**STAFF REPORT
GREENFIELD PLAN COMMISSION
TUESDAY, APRIL 10, 2018
6:30 PM**

- 1. Roll Call**
- 2. Approval of the minutes from the March 13, 2018 meeting.**
- 3. Discussion regarding last Common Council meetings.**
- 4. Site and Landscaping Plans for O Yeah Chicken & More, a proposed restaurant to be located at 3322 W. Loomis Rd., submitted by Adnan Bin-mahfouz, d/b/a Halal Investments, LLC. (Tax Key No. 553-0436-001)**

Site and Landscaping Plans

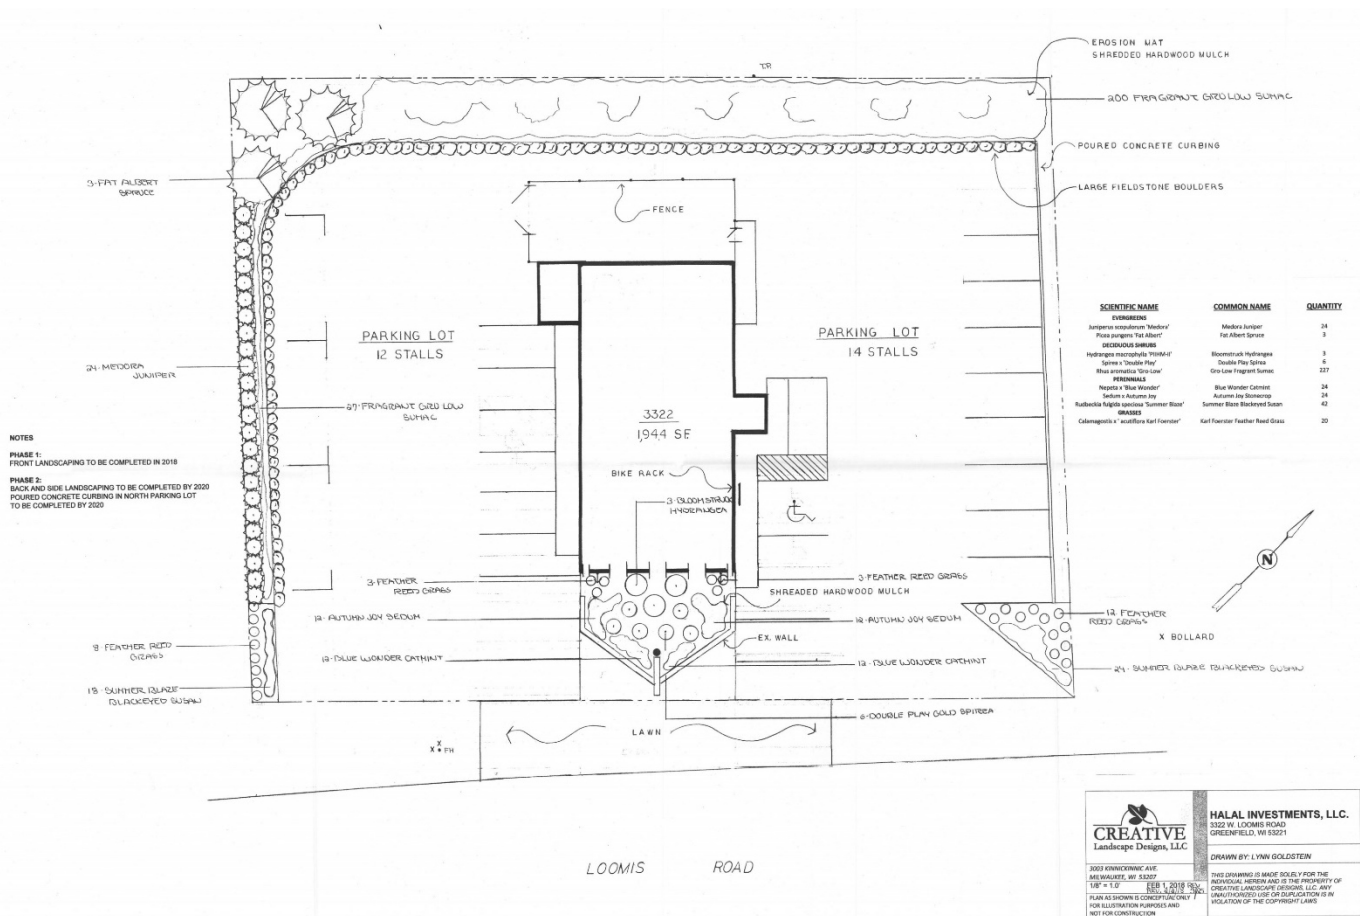
This item was before the Plan Commission last month (March 13, 2018) and was held to allow the applicant time to put together a phased site/landscaping plan. The site/landscaping plan is tied to a proposed Special Use Permit to open a restaurant at 3322 W. Loomis Rd. A public hearing is scheduled for April 17, 2018.

The applicant, the applicant's landscape designer, and the City Forester met on site to prepare a phased landscaping improvement plan. The property has no landscaping—only a small planter bed in the front along W. Loomis Rd. where the existing monument sign is located (with no landscaping planted in it).

1. Landscaping in front of the building within the existing landscape bed.
2. Extension of landscaping/grass in the State right-of-way, replacing the two (2) parking spaces in the right-of-way (applicant is trying to contact WisDOT).

3. Landscaping being installed in the painted triangle in the northeast corner of the property.
4. Bollards being placed around the existing fire hydrant along W. Loomis Rd. for protection purposes.
5. New chain link slats being placed where missing within the refuse enclosure in the rear of the building.
6. A bike rack being provided on site.

1. Removal of the poured asphalt along the west and south property lines, to be replaced with large fieldstone boulders and various landscaping.
2. Poured curb around perimeter parking rather than wheel stops.

Recommendation: Recommend Common Council approval of the Site and Landscaping Plans for O Yeah Chicken & More, a proposed restaurant to be located at 3322 W. Loomis Rd., submitted by Adnan Bin-mahfouz, d/b/a Halal Investments, LLC. (Tax Key No. 553-0436-001), subject to Plan Commission comments, staff comments, and the following conditions:

1. An estimated cost of landscaping and screening being submitted to the Community Development Division for approval.
 2. A letter of credit or other form of security as required under 21.06.0304 of the Municipal Code in the amount of 125% of the estimated cost of landscaping and screening.

3. Easement or grant of privilege being provided by WisDOT for landscaping and other site work in the State right-of-way.
 4. Common Council approval of the Special Use Permit for O Yeah Chicken & More, a proposed restaurant to be located at 3322 W. Loomis Rd., submitted by Adnan Bin-mahfouz, d/b/a Halal Investments, LLC following a public hearing scheduled for April 17, 2018.

EAST PERSPECTIVE

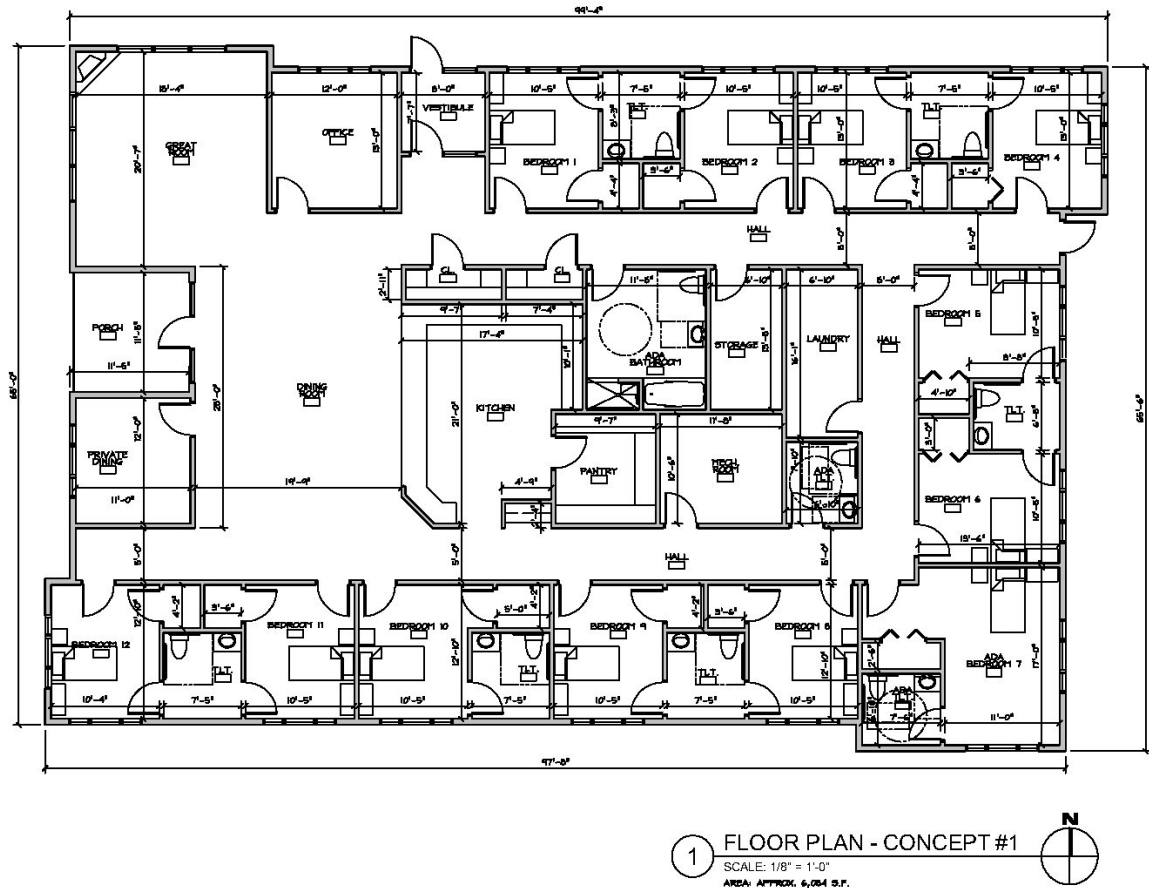
The proposed buildings would be constructed in phases and would be approximately 6,000 sq. ft. each. The proposed buildings would be one-story tall with no basement. The building design follows a residential style with pitched roofs, single-hung cottage-style windows and vinyl siding and trim with a stone base around the building. Each building has a low density traffic flow, as each building is limited to three (3) employees/building.

The applicant has an architect and civil engineer on board to address the wetlands in the rear of the parcel. The City's Engineering Department has had preliminary conversations with the applicant's team regarding the wetlands. The proposed site plan utilizes the existing driveway approach off of S. 35 St.

4' x 6' Cape Cod Spaced Picket Fence Panel

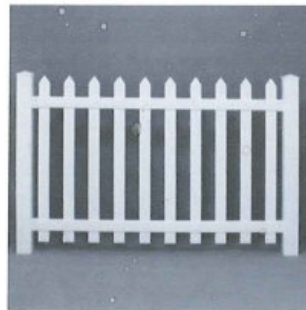
Resurrection Power Ministries, Inc. purchased the property located at 3131 S. 100 St. in December 2016. The previous occupant had a lease with We Energies to utilize the parking lot across the street on the east side of S. 100 St.; however, Resurrection Power Ministries, Inc. did take over that lease as part of their purchase in December 2016. Resurrection Power Ministries, Inc. has 34 parking spaces provided on site. The daycare will provide a designated fenced-in outdoor play area in the rear of the building with mulch covering over the pavement. There is greenspace to the north of the building/parking lot, however, that land is owned by Milwaukee County, so the daycare is not able to utilize it for their dedicated outdoor play area. The fence material will be a white Cape Cod spaced picket fence. The outdoor play area is heavily screened by trees and brush along S. 100 St.

5., 6., & 7.

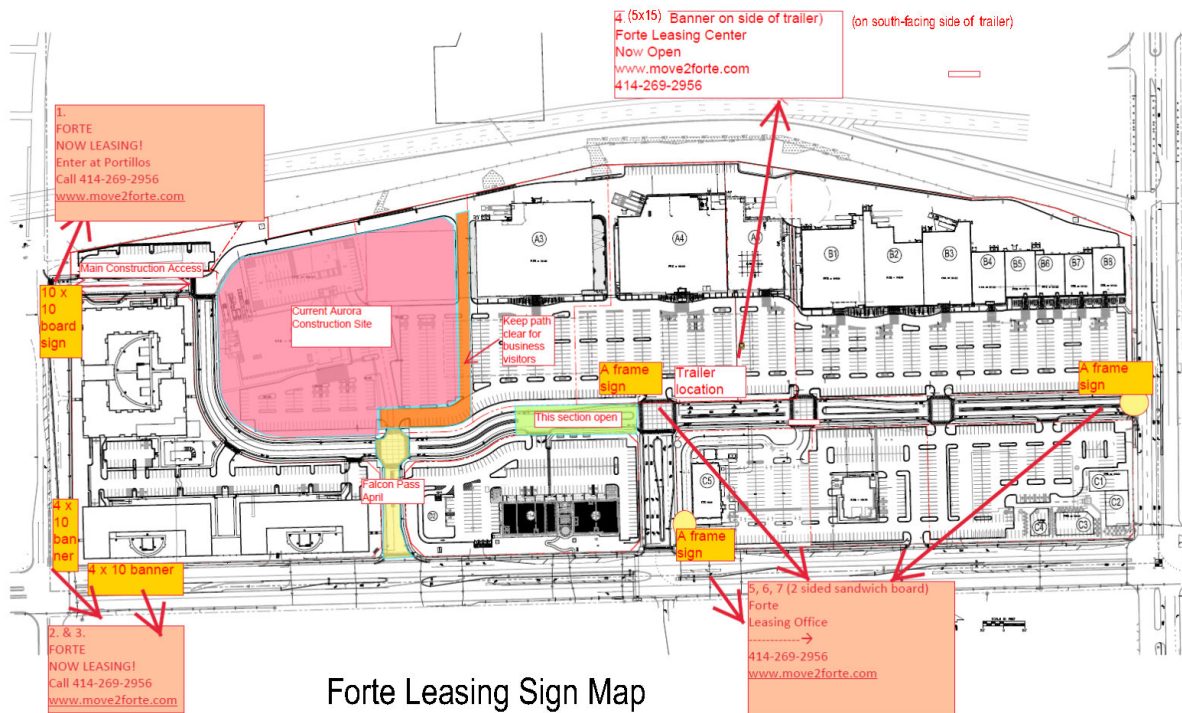
Sandwich board with 24x36 Aluminum Blanks as per sketch

- Two (2) 4' x 10' vinyl banners to be mounted on the chain link fence on the corner of S. 92 St. and W. Layton Ave.
- One (1) 5' x 15' vinyl banner to be mounted on Forté's leasing trailer that is located near Sura Ln., in front of Steinhafel's.
- Three (3) 2' x 3' aluminum A-frame sandwich board signs to be located along W. Layton Ave.

- Temporary banners are limited to 24 sq. ft. in area—the proposals exceed the size limitation.
- Temporary signs are limited to 30 days—the proposal exceeds the time limitation.
- A-frame/sandwich board signs are not permitted—the proposal includes three (3) A-frame/sandwich board signs.

Given the fact that the City has financially participated in the 84 South project and relies on the success of development and leasing of apartment buildings for the tax base to increase within the development boundaries, staff recommends approval of the temporary signage plan appeal.
